**ADDENDUM
NO. 03**

**Edwardsburg Public Schools – Parent Drop Off Loop
69100 Section St
Edwardsburg, MI 49112**

ADDENDUM NO. 3

ARCHITECT'S PROJECT NO.: 21-201.031

2
OUTDOOR ELECTRICAL EQUIPMENT CONCRETE PAD DETAIL
ES 002 NOT TO SCALE

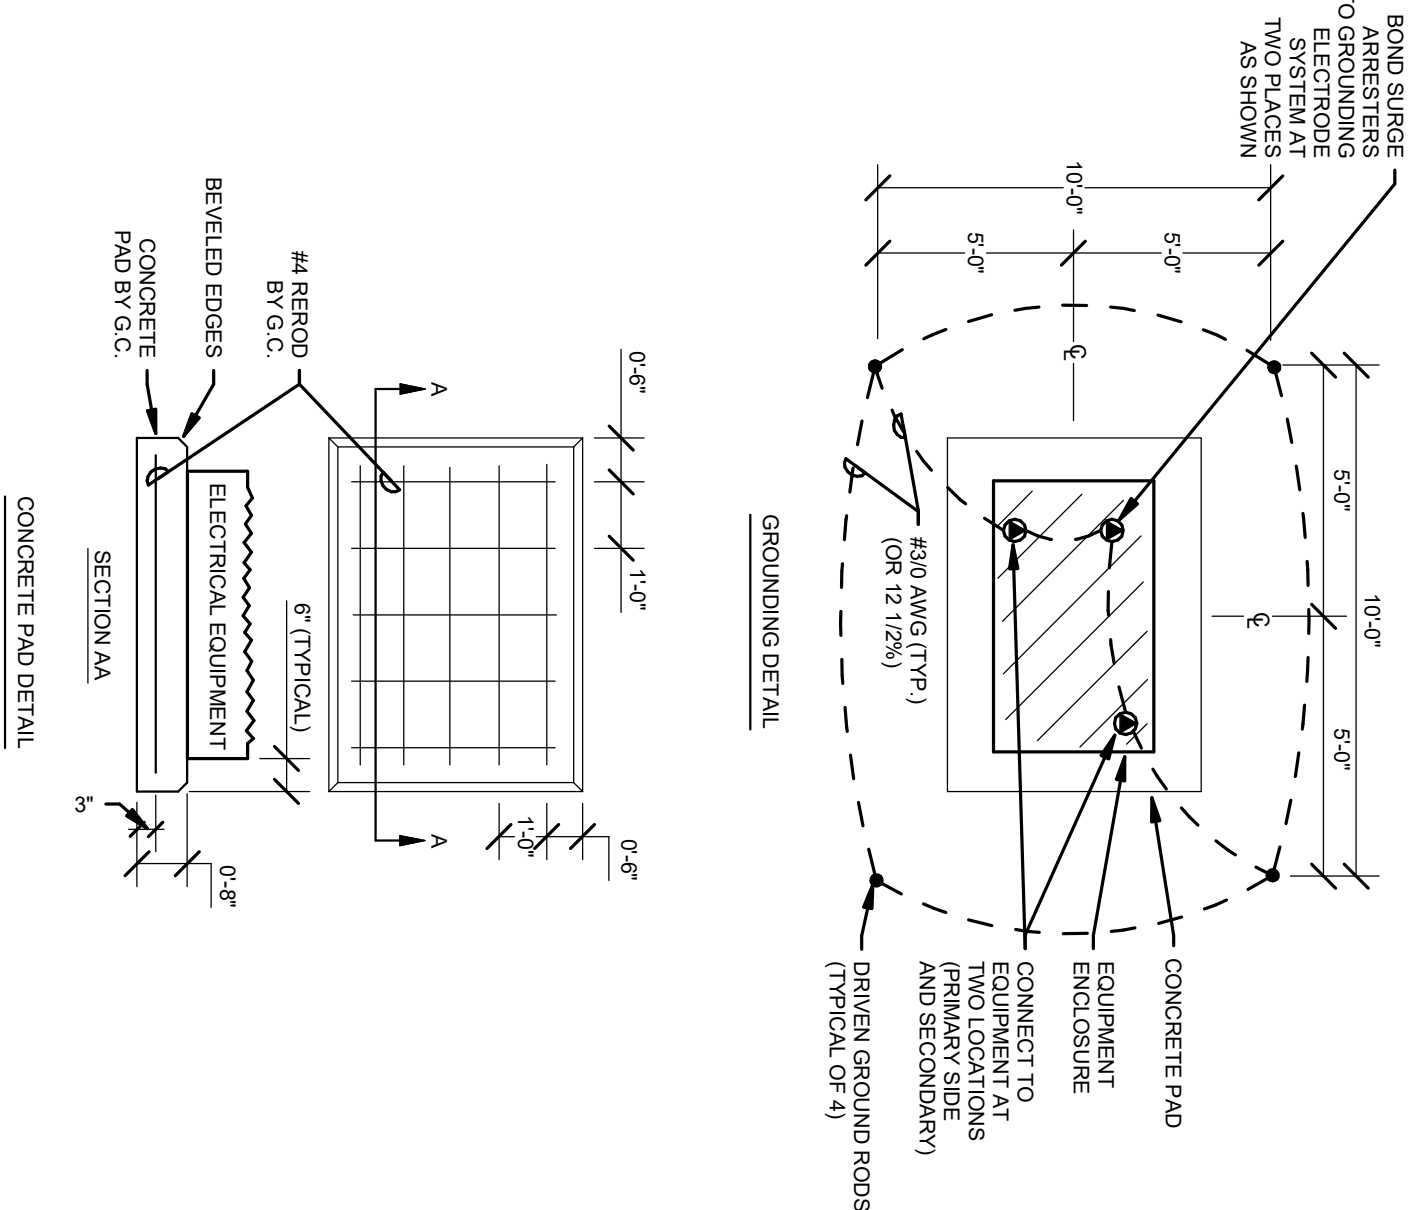
ADD-2 Item No. D-5 - Outdoor Electrical Equipment Concrete Pad Detail

Refer to Sheet(s): ES002

Add detail, as shown on drawing.

ELECTRICAL SITE PLAN
SCALE: 1" = 100'-0"

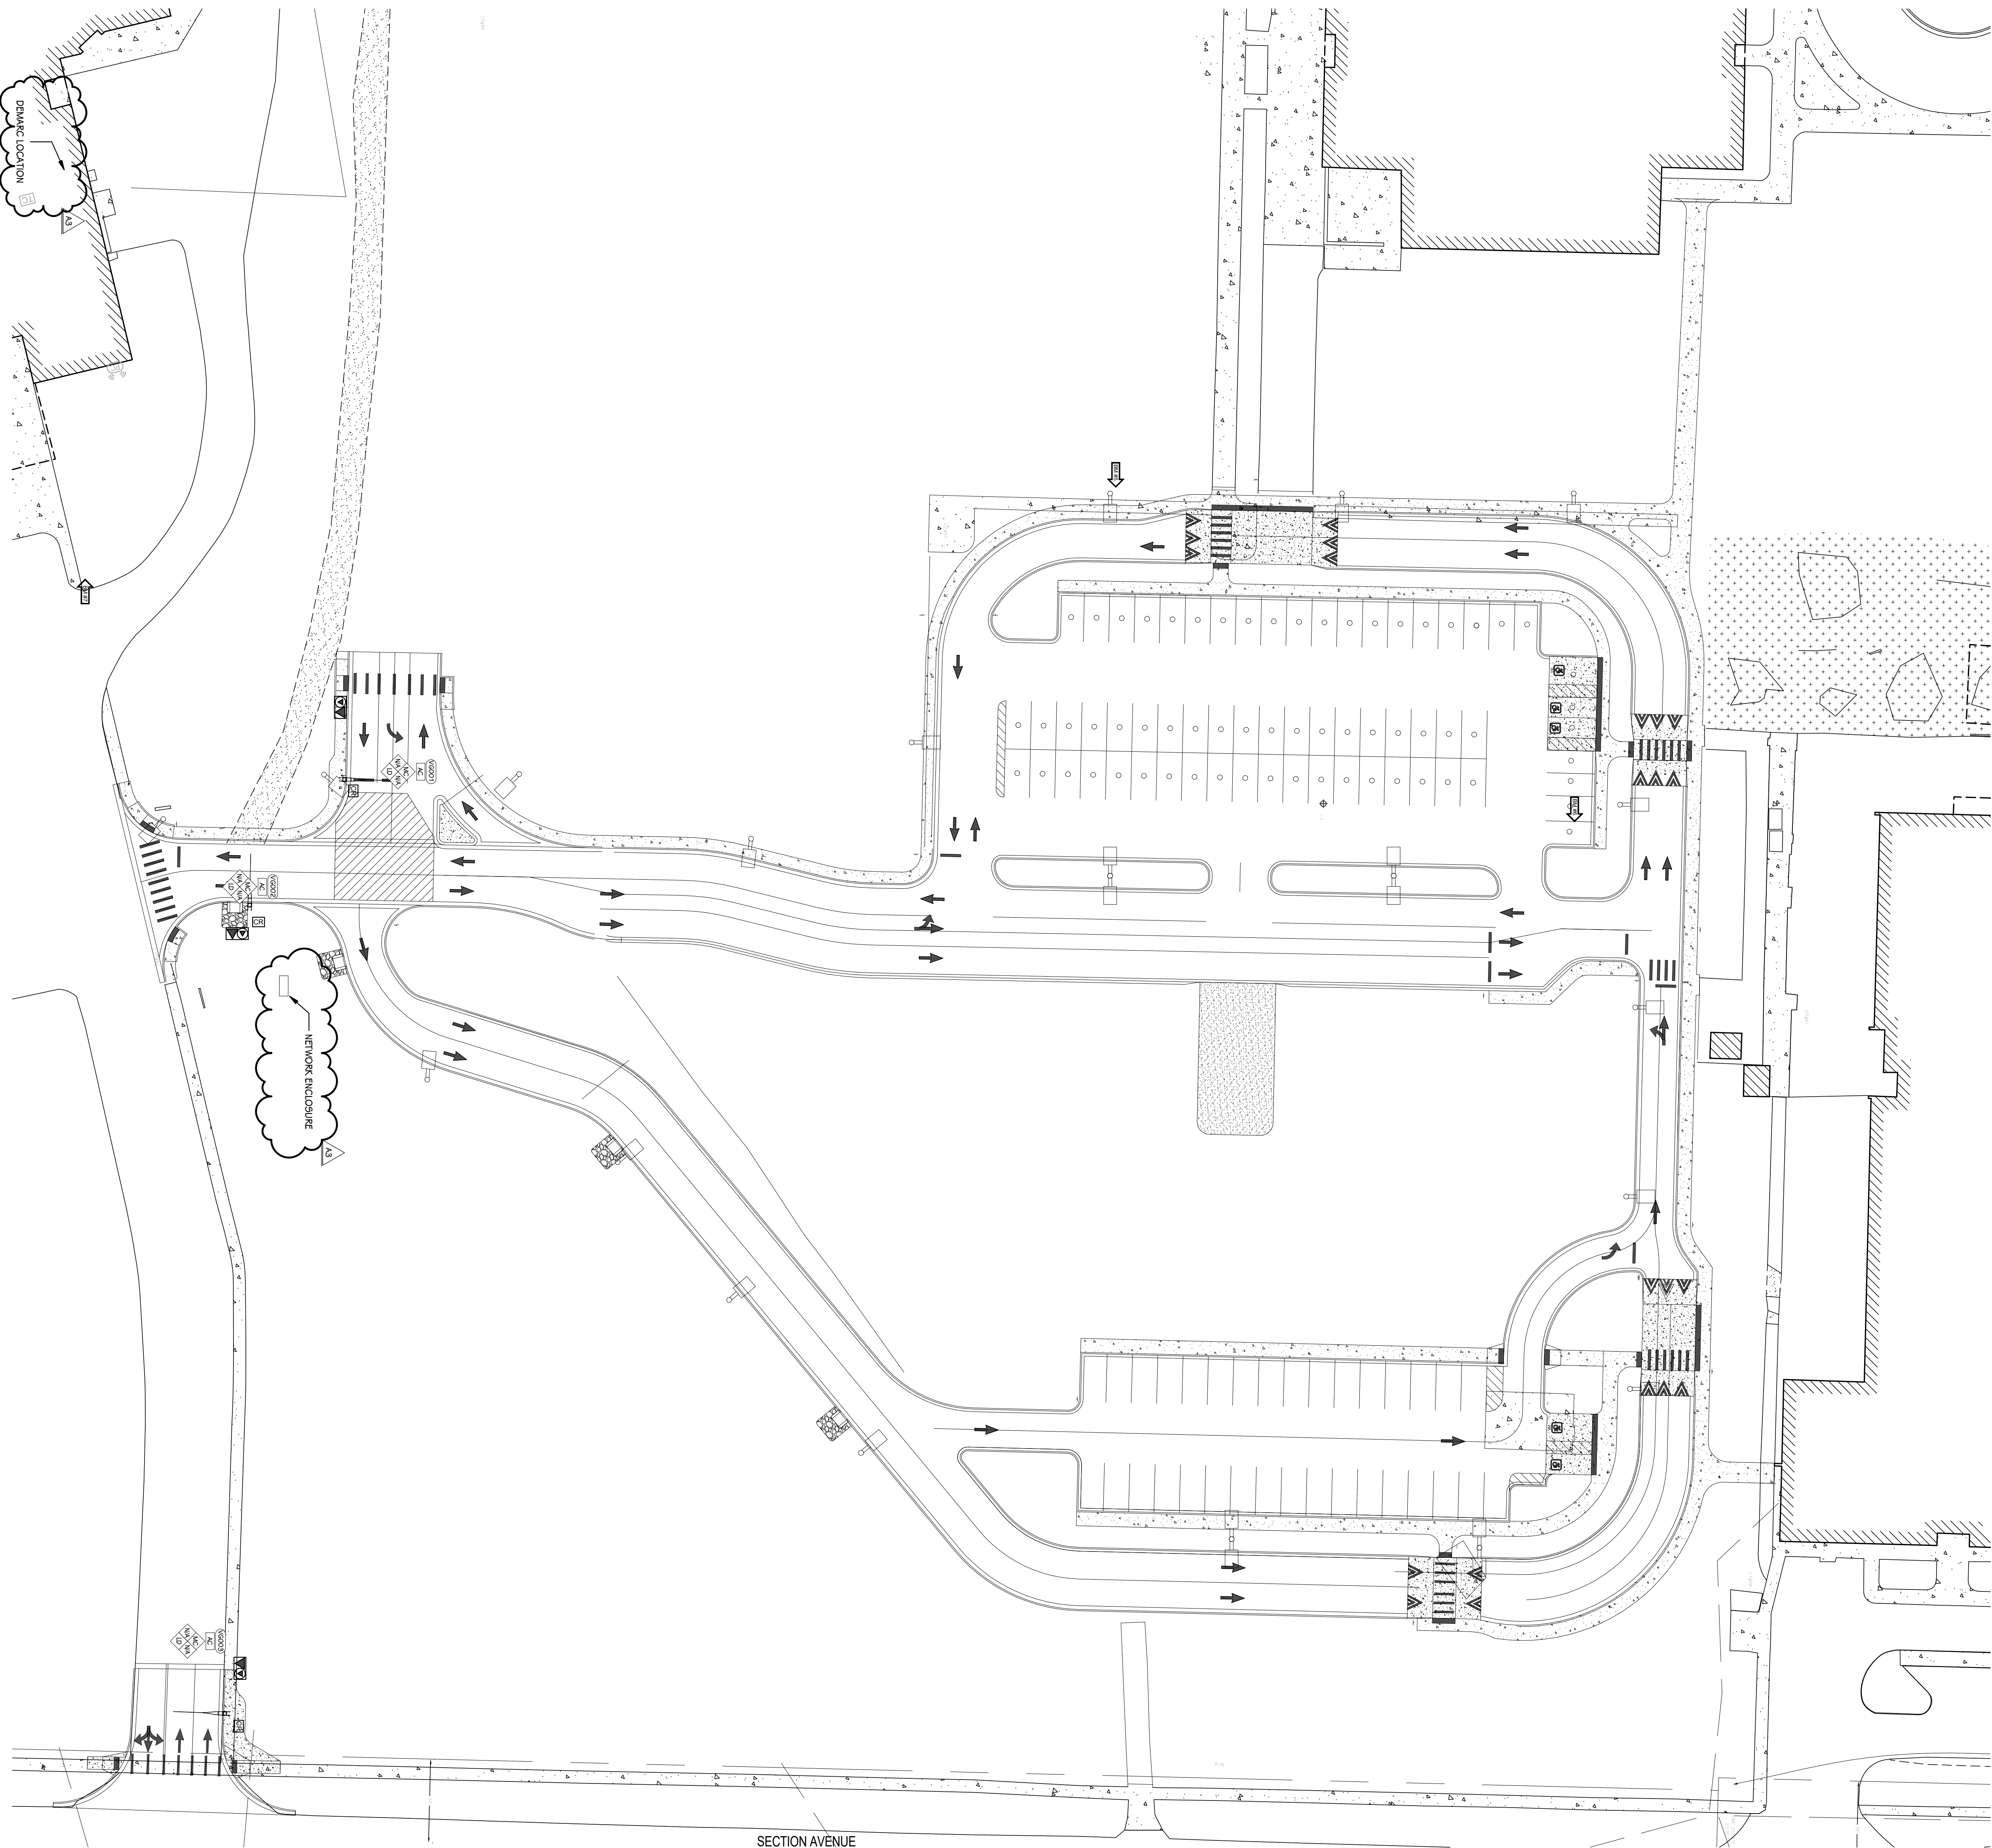
ADD-2 Item No. D-4 - Site Luminaire Layout

Refer to Sheet(s): ES002

Revise site luminaire types, quantities, and locations, as shown on drawing.

ADD-2 Item No. D-2 - Relocation of Network Enclosure

Refer to Sheet(s): TS101, ES002

Relocate network enclosure and all conduit to the network enclosure to the East of the drive lane.
